LONG ISLAND LIGHTING COMPANY

SHOREHAM NUCLEAR POWER STATION

SNRC-601

SHOREHAM NUCLEAR POWER STATION - Unit 1
Docket No. 50-322

FIGURE 13.1-4
SHOREHAM PROJECT ORGANIZATION

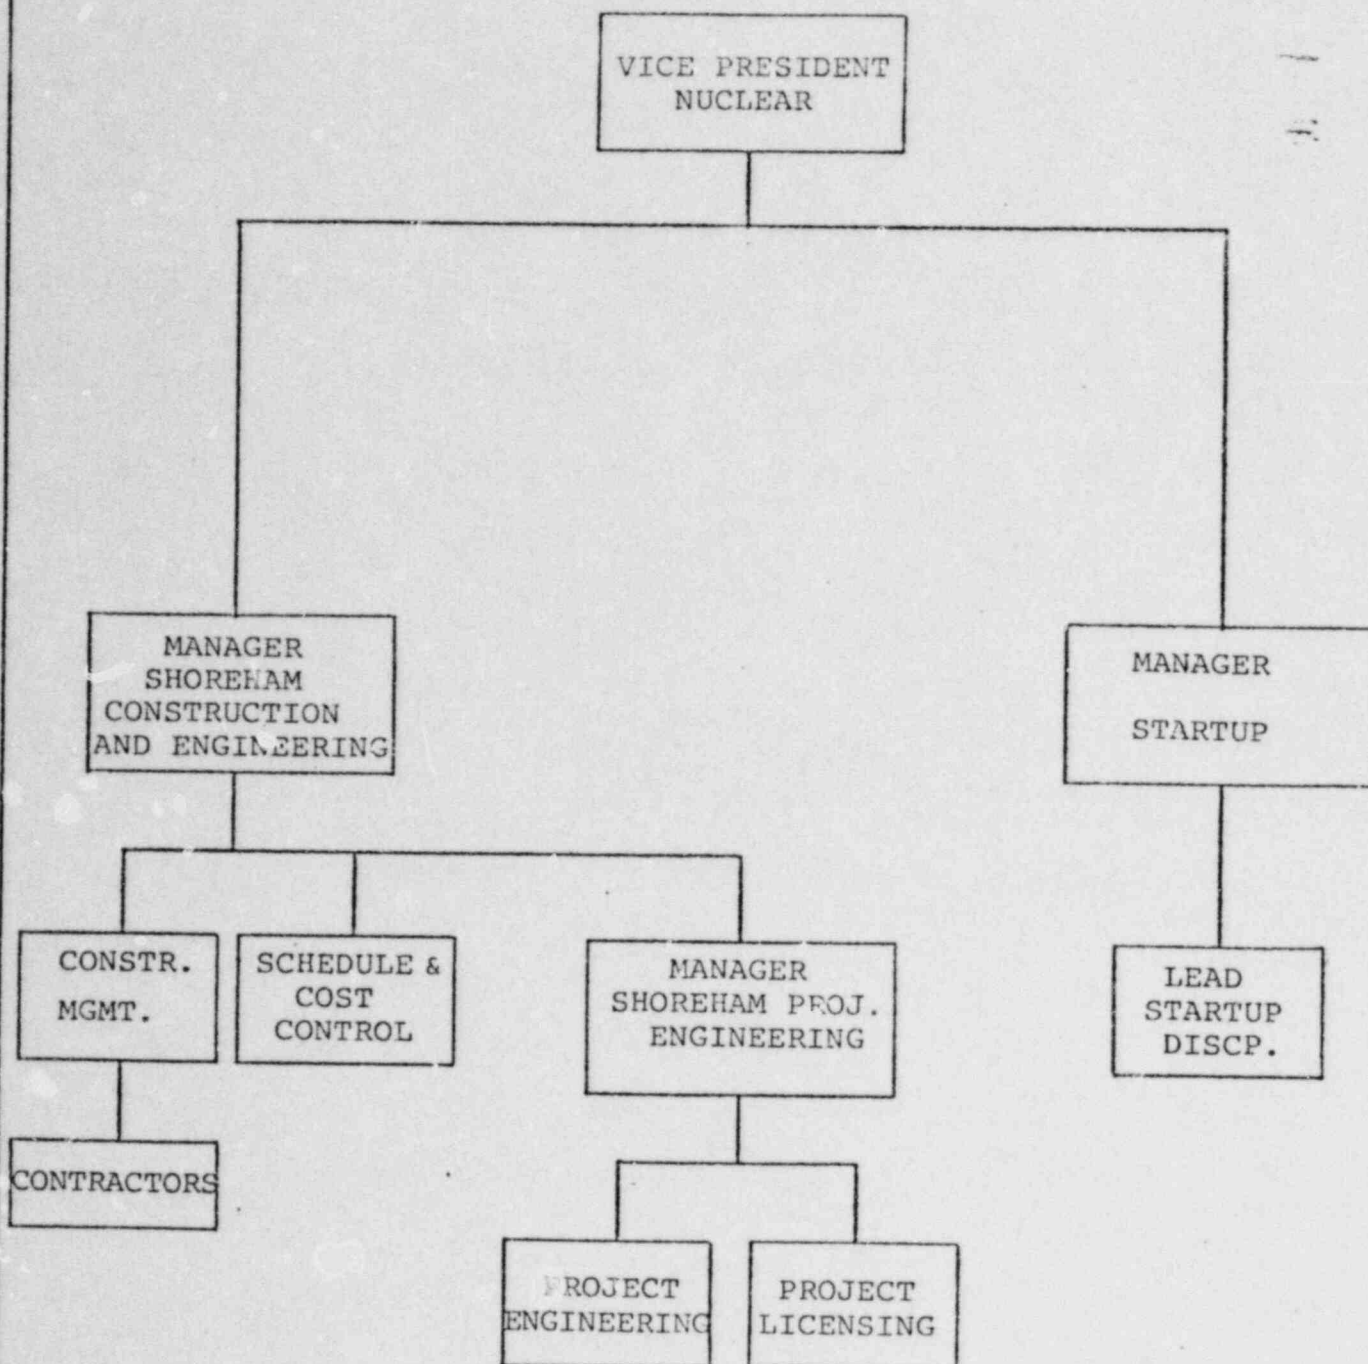
1. Effective July 1, 1981 there has been a reorganization of some of the functions under the office of Vice President Nuclear. Attached are revised Figures 13.1-1 and 13.1-4 which reflect the current organization.
